INDESIT company

Model type:
MBA45D1NFI

Commercial code:
F038771

RE0223T0 Exploded views

RE0224T0 Exploded views

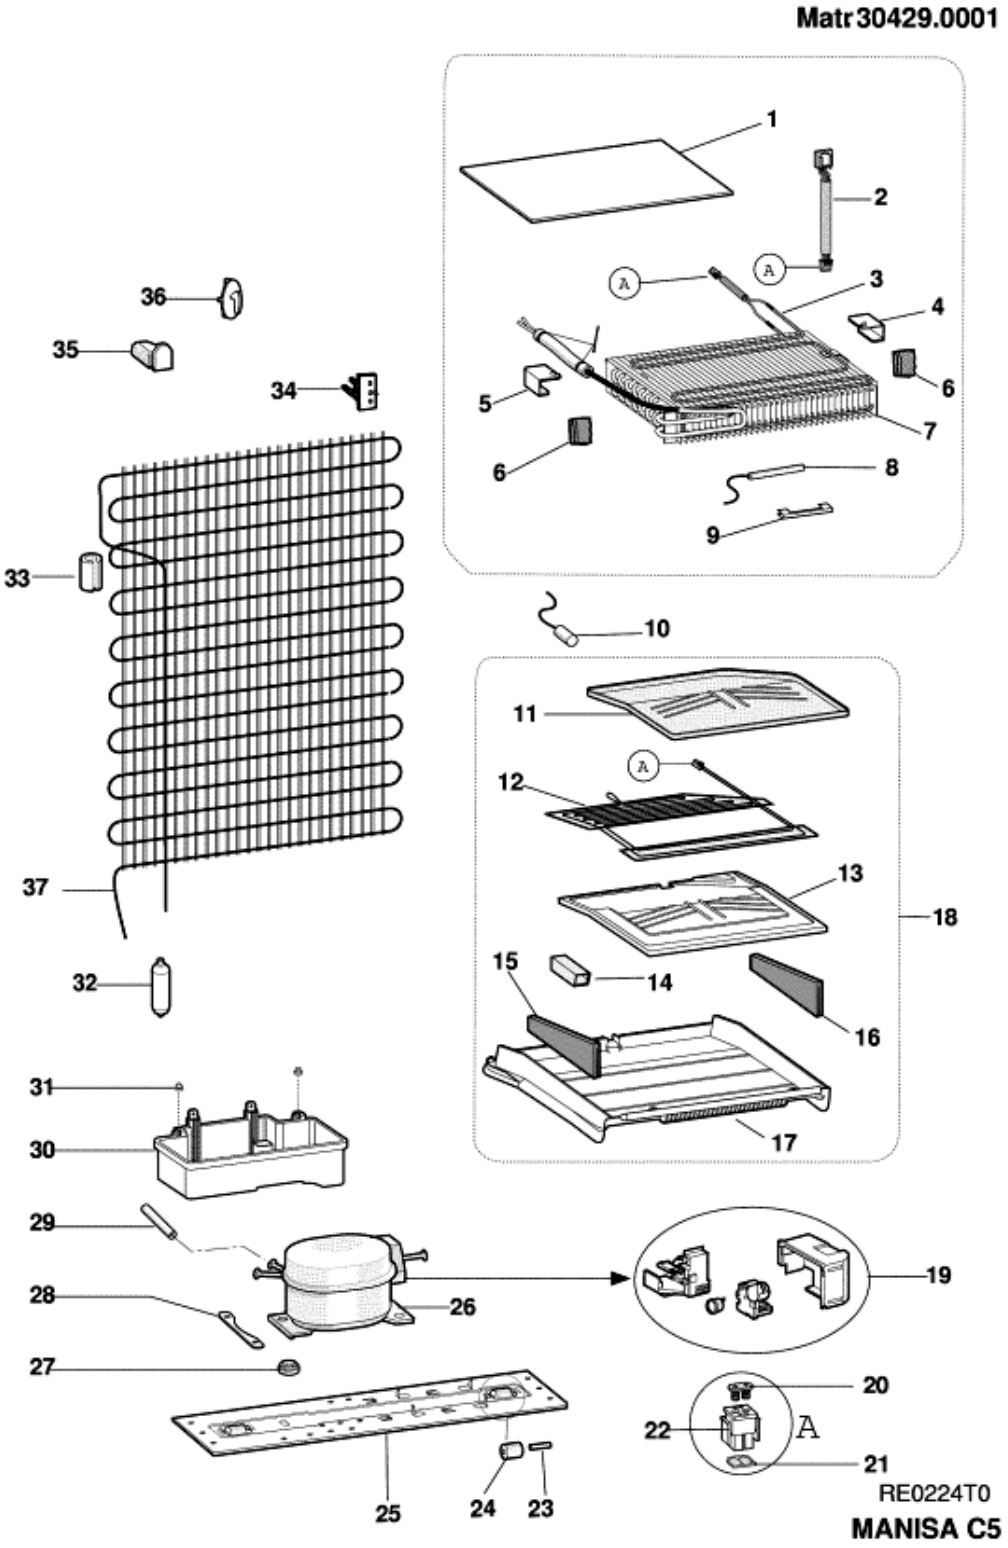
## 0999376: ICE FORMATION AT THE BACK OF THE EVAPORATOR

Below modifications have been performed to prevent ice formation at the back of the evaporator on L70 combies. These new parts can be supplied as an assembly C00141277
1- Spugnetta evaporatore left and right have been modified since 12/08/2005. Spare part codes remain the same (C00094468-C00094467). These parts must be replaced together in case of necessity of the replacement.

2- Power of the rezistance for divisorio camere has been increased from 40W to 50W since 03/10/2005. Spare part code remains the same (C00095774).

3- Power of the rezistance for evaporator has been increased from 140W to 150W since 26/09/2005. Spare part code remains the same (C00115199).

4- Drain hose end piece C00141278 has been used for draining the water to the evaporating tray since 26/09/2005.

5- Fan motor plastic assembly has been modified. The hole for propeller has been modified to prevent friction between propeller and fan motor plastic since 03/10/05.
Spare part code remains the same (C00116498).

These new parts can be supplied as an assembly C00141277.(TB001014 - ex.TECHNICAL NEWS STN-CL 0511.1)

RE0225T0

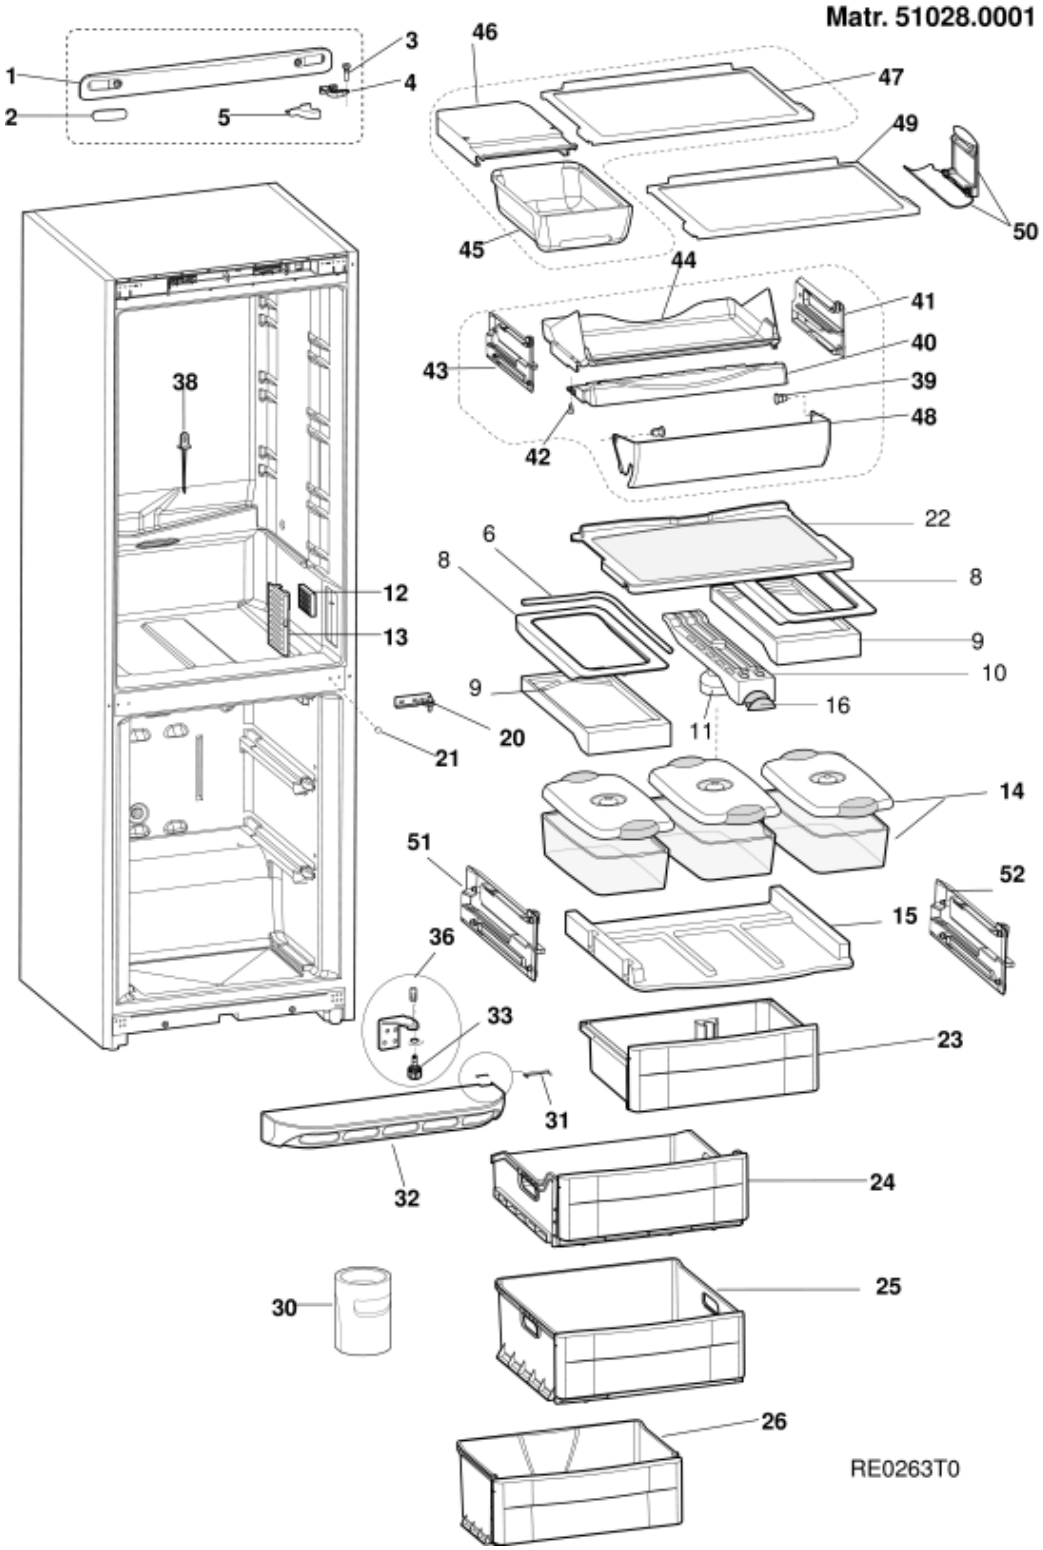
## 0999379: TWO HOLES HAVE BEEN CANCELLED ON MULTIFLOW FOR COMBIES

Due to low temperature at the lower part of the fridge section on Manisa combies two holes which are placed on multiflow cover have been cancelled for all combies since 13/04/2006.
